STAFF REPORT
CITY OF LAKE OSWEGO

LU 13-0004

The applicant is requesting approval of a modification of a Development Review permit [DR 15-95/SD 19-95 (Mod 3-97)] for five additional parking lot lights with single-head 150-watt high pressure sodium lamps.

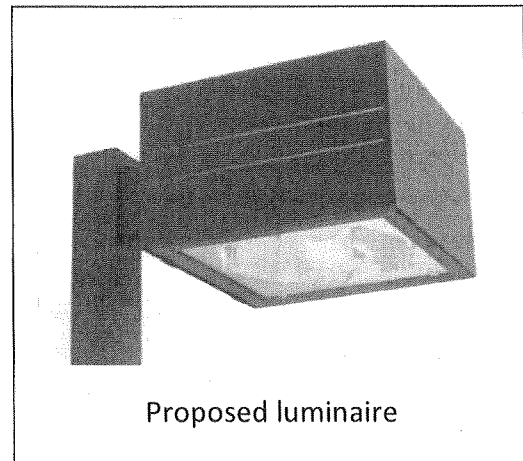
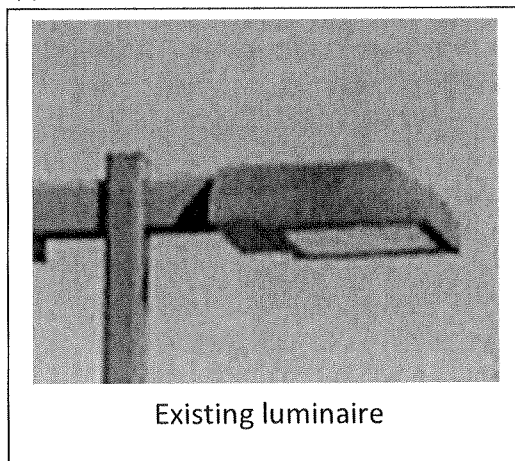
As can be seen from the inset photo and graphic, the design of the proposed box-shaped luminaire differs in design from the existing luminaires with low rounded profiles. As a condition of approval, the applicant should submit cut sheets for a luminaire that is substantially similar to the existing, to the satisfaction of staff. As conditioned, this criterion can be met.

1. Submit final photometric plans and specifications for the review and approval of staff, that are the same or substantially similar to the plans and specifications illustrated on Exhibits E2-E6 and F2 with the following modifications:
 - a. Provide a plan with specific foot-candle illumination levels for each proposed and existing luminaire in order to determine compliance with minimum, maximum, and uniform lighting standards, to the satisfaction of the City Engineer.
 - b. Modify the proposed luminaire to a housing style substantially similar in size, style, and profile to the existing luminaires and provide cut sheets, to the satisfaction of staff.
